**DEVELOPMENT REVIEW BOARD  
RESOLUTION NO. 426**

**A RESOLUTION ADOPTING FINDINGS AND CONDITIONS OF APPROVAL, APPROVING A SITE DESIGN REVIEW OF PARKS AND OPEN SPACE IN THE CANYON CREEK PHASE 3 SUBDIVISION.**

DB23-0012 Site Design Review of Tract A Open Space: Site Design Review of Parks and Open Space (SDR23-0008).

Exhibit A1  
Staff Report  
Wilsonville Planning Division  
Site Design Review of Tract A Open Space  
28700 SW Canyon Creek Road South

Tract A Open Space Location  
in DB20-0039 et seq

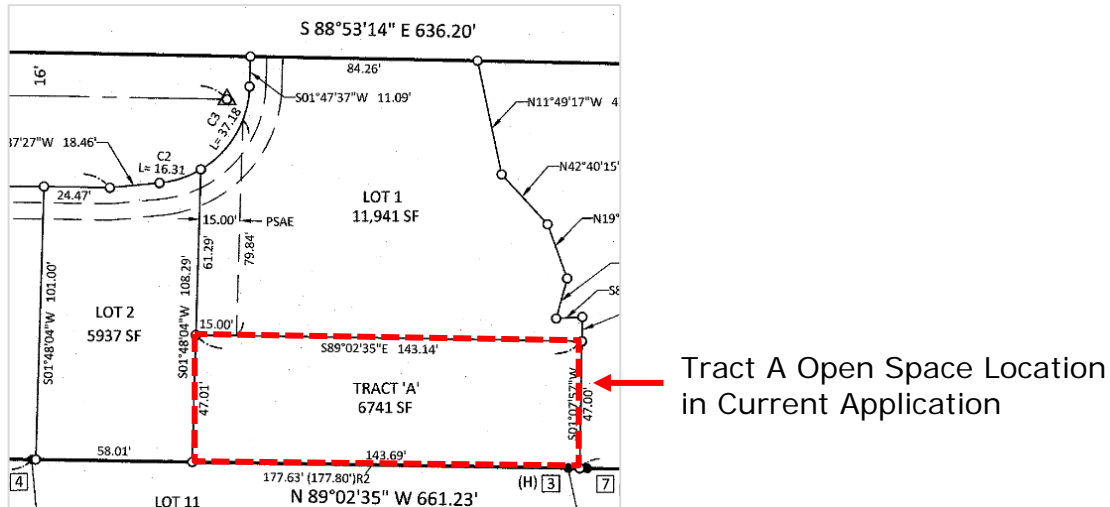
In response to public testimony received and subsequent discussion by the DRB at the hearing, Condition of Approval DRB 1 was added requiring the plans to be updated to swap the location of the Tract A open space with Lot 1, as illustrated below and proposed in the current application.

In addition, as further explained in Finding E1 of the DRB decision for DB20-0039 et seq, although the applicant previously proposed a professionally designed open space meeting the applicable standards for Site Design Review, this late change to the location of Tract A did not provide the applicant’s design team time to complete a professional design of the relocated open space. At that time the DRB was required to make a decision on other related applications, no evidence on the record would prevent a design of the proposed open space area meeting applicable City standards, and certainty existed that such a design could be created. Thus the DRB decision also included Conditions of Approval PDD 14 and PDE 1 specific to the Tract A open space, as follows:

- **PDD 14. Prior to Final Plat Approval:** The applicant shall submit a revised Sheet L1 showing the landscaping plan to match the new shape and square footage of the proposed usable open space area in Tract A. If the project landscape architect changes, the applicant shall submit a new Affidavit of Professional Credentials for Residential Usable Open Space Areas in the City of Wilsonville. For final approval of the revised open space area, the applicant shall return to the Development Review Board for review of the redesigned open space. See Finding D49.
- **PDE 1. Prior to Final Plat Approval:** The applicant shall submit landscape plans meeting applicable design standards and receive DRB approval of the landscape plans for the usable open space (Tract A) and install the approved landscaping unless such landscaping installation is deferred based [on] written agreement with the City.

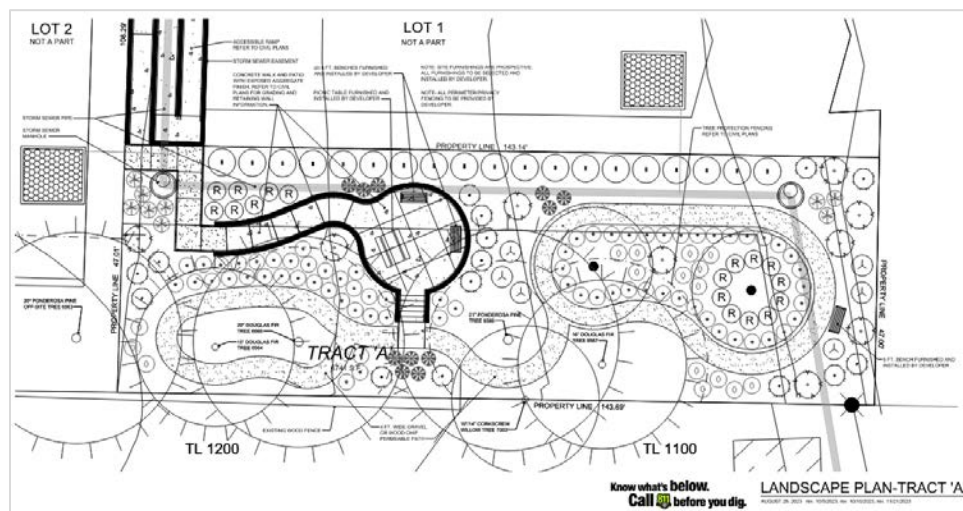
As demonstrated in the Findings, the Tract A open space, shown below and in the applicant's submitted plans (Exhibit B2), has been designed by a registered professional landscape architect and conforms with the Site Design Review criteria for open space in residential subdivisions.
